Amendments to the Drawings:

REMARKS/ARGUMENTS

Appl. No. 10/037,278
Amdt. dated January 3, 2006
Reply to Office Action of September 2, 2005

FIG. 1F

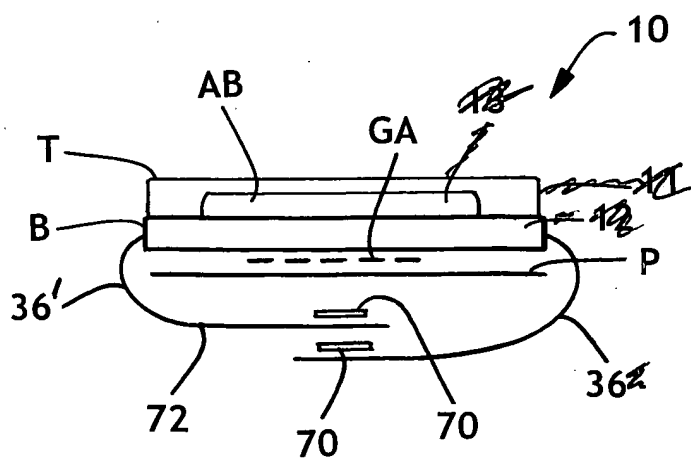
Regarding Fig. 1F, Applicants have resubmitted Fig. 1F and have deleted reference numerals 11, 12 and 13. In addition, the left flap has been relabeled 36' and the right flap has been relabeled 36, at the Examiner's request. Further, the specification at page 5 has been amended to state that Fig 1F shows a cross-section.

On page 4 of the Office Action, the Examiner objects to the drawings under 37 CFR 1.83(a) on the basis that the drawings do not show the sheets, the core and the perforation lines. The Examiner's attention is directed to Fig. 1F, which clearly shows the top sheet, the backsheet and the absorbent core. Therefore, these features are clearly shown by the drawings. In addition, Figs. 1D and 1E show the perforation lines 71 and the corresponding text in the specification at page 9, line 20, et seq. was amended to indicate that Figs. 1D and 1E show perforation lines 71. Therefore, the Examiner's objection to the drawings under 37 CFR 1.83(a) is improper, since the noted features are shown in the drawings.

The attached are two sheets of drawings which include changes to Fig.1F and Fig. 2D. These sheets, which includes Fig.1F and Fig. 2D, replace the original sheets including Fig.1F and Fig. 2D.

FIG. 2A

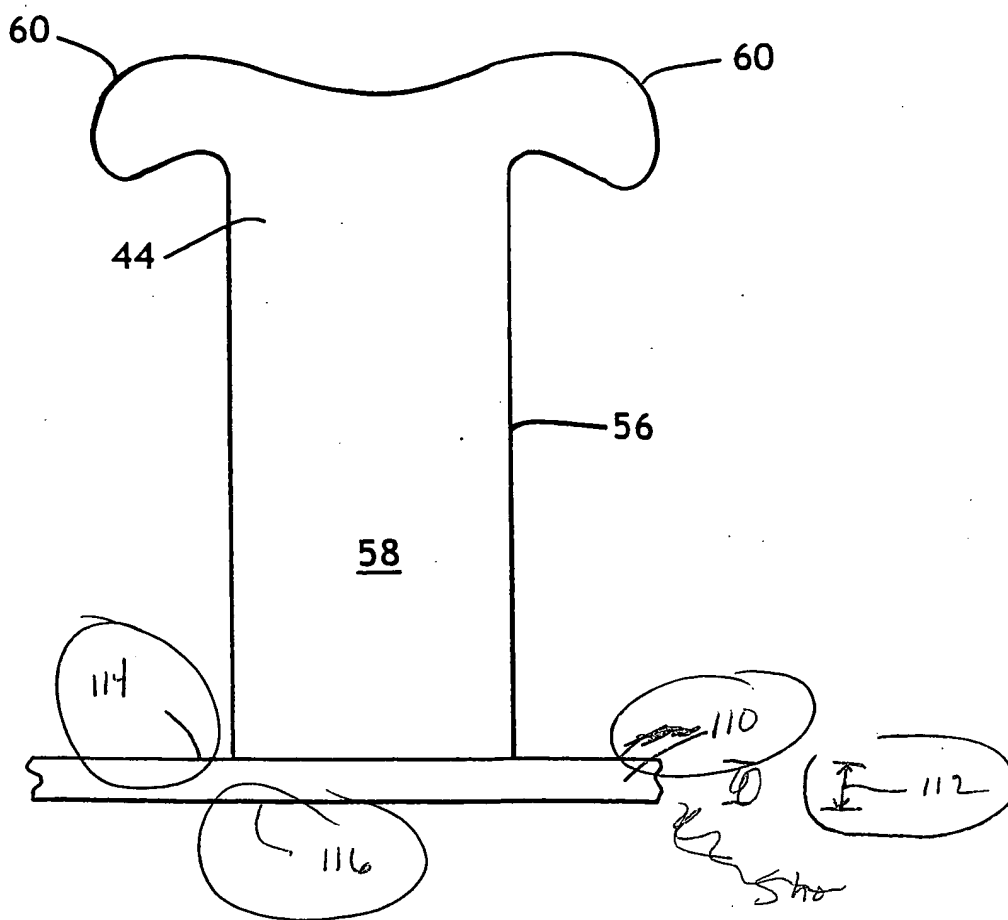
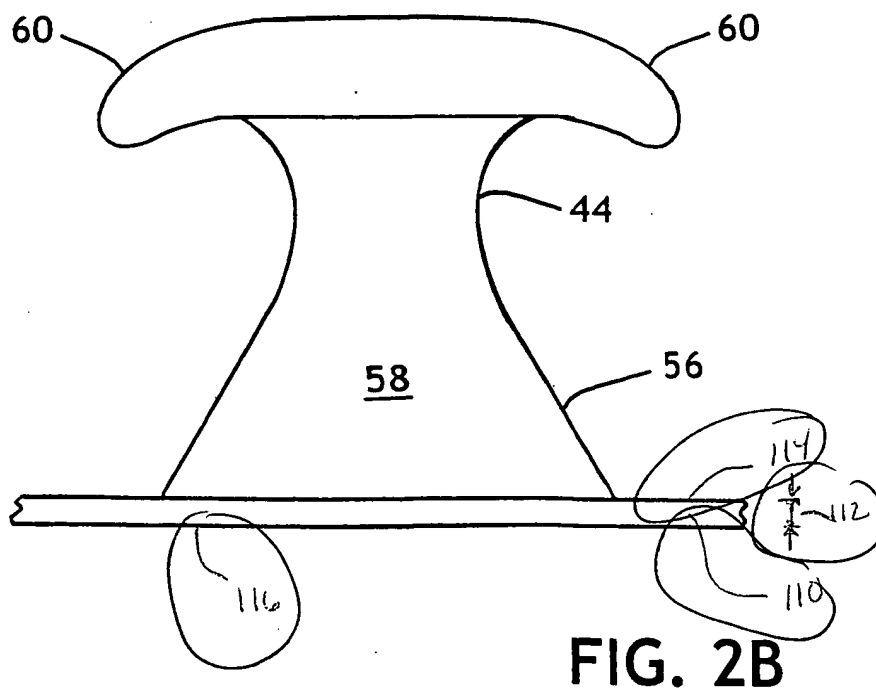
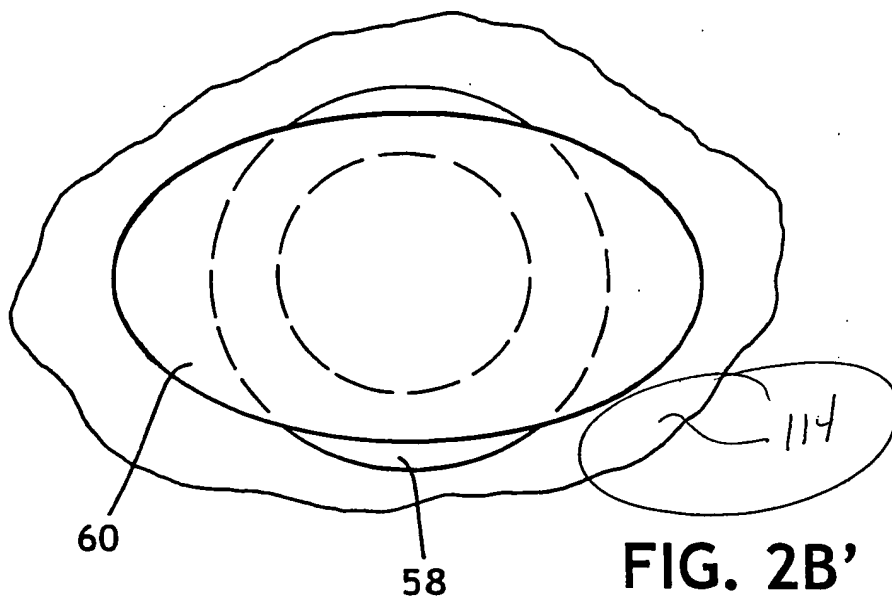
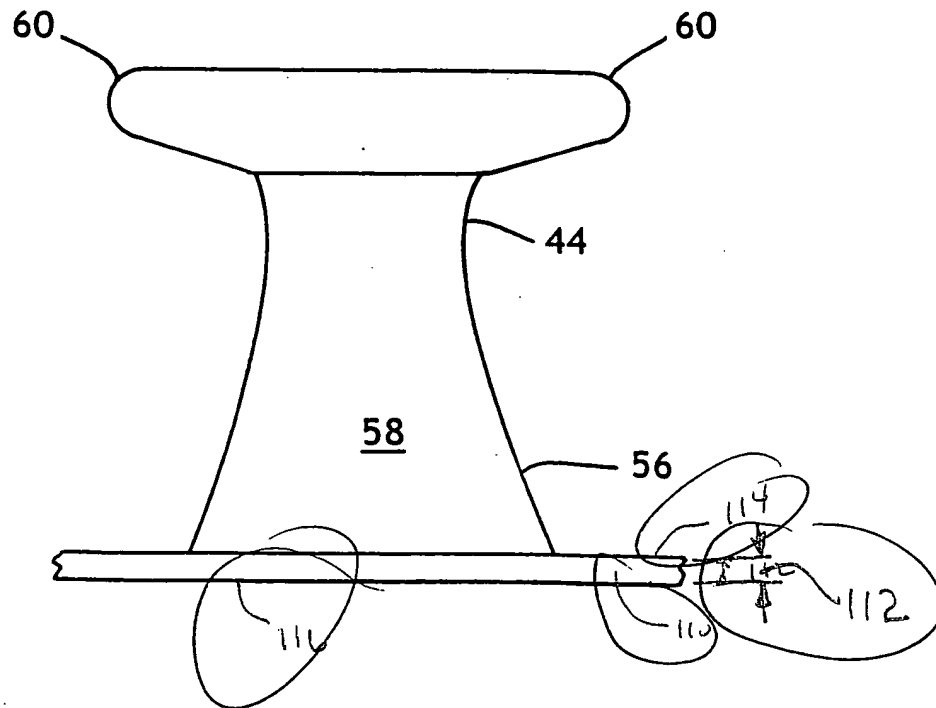
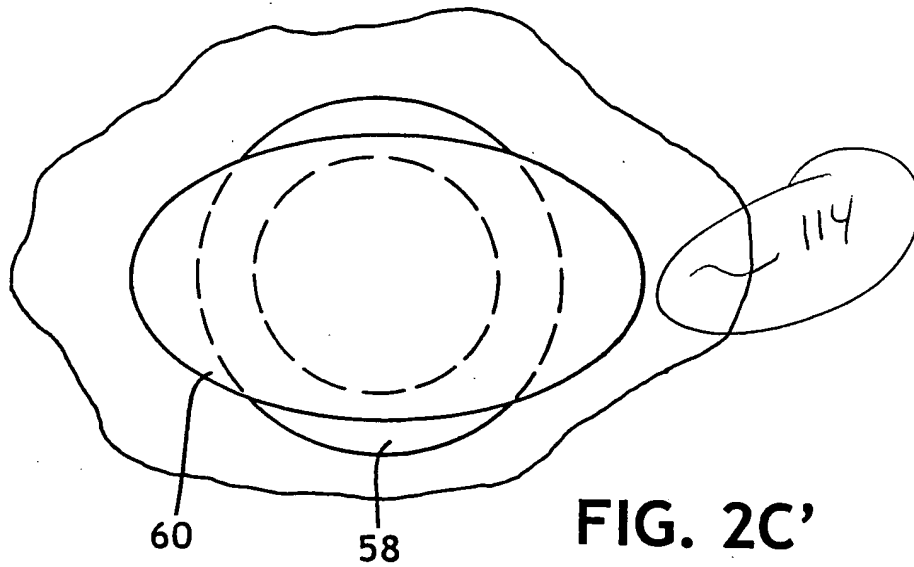
The Examiner also states in the Office Action that the submitted drawings did not include replacements sheets for Figs. 2A-2C'. Applicants have included new replacement sheets for Figs. 2A-2C', as well as the annotated figures previously submitted.

The Examiner also finds that elements 110, 112, 114 and 116 are not shown in Figs. 2A - 2E as described in the paragraph on page 13, line 16. Applicants again direct the Examiner's attention to the Amendment filed July 28, 2004. This paragraph was amended to refer to Figs. 2A-2C' and does not refer to drawings 2D or 2E. Figs. 2A - 2C', which are attached hereto, show each of elements 110, 112, 114 and 116, as set forth in this paragraph, as it is currently amended.

In addition, replacement sheets for Figs. 2A – 2C' are also attached to replace the replacement sheets filed July 28, 2004, which were apparently misplaced by the U.S. Patent Office.

FIG. 2D

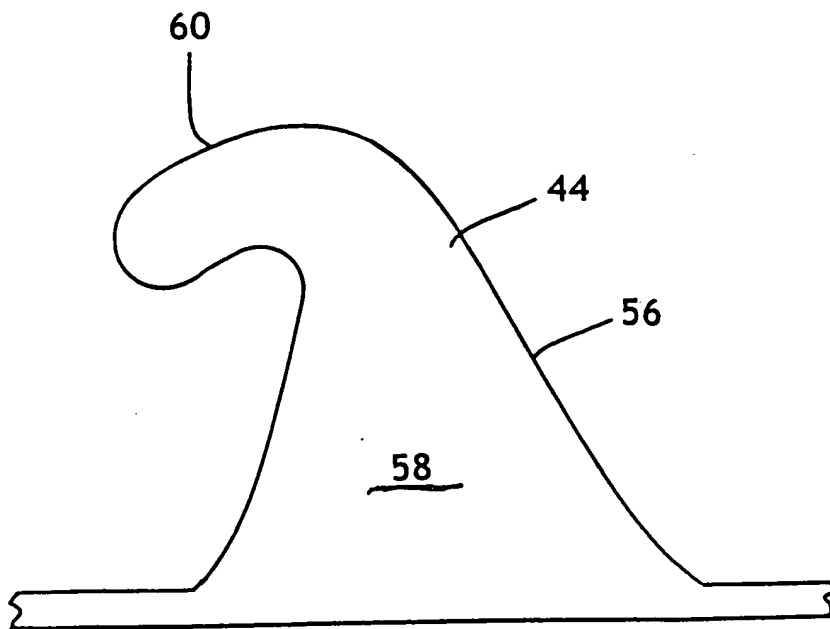
Regarding Fig. 2D, the attached correction to Fig. 2D underlines element 58. Hence, this objection should be overcome.
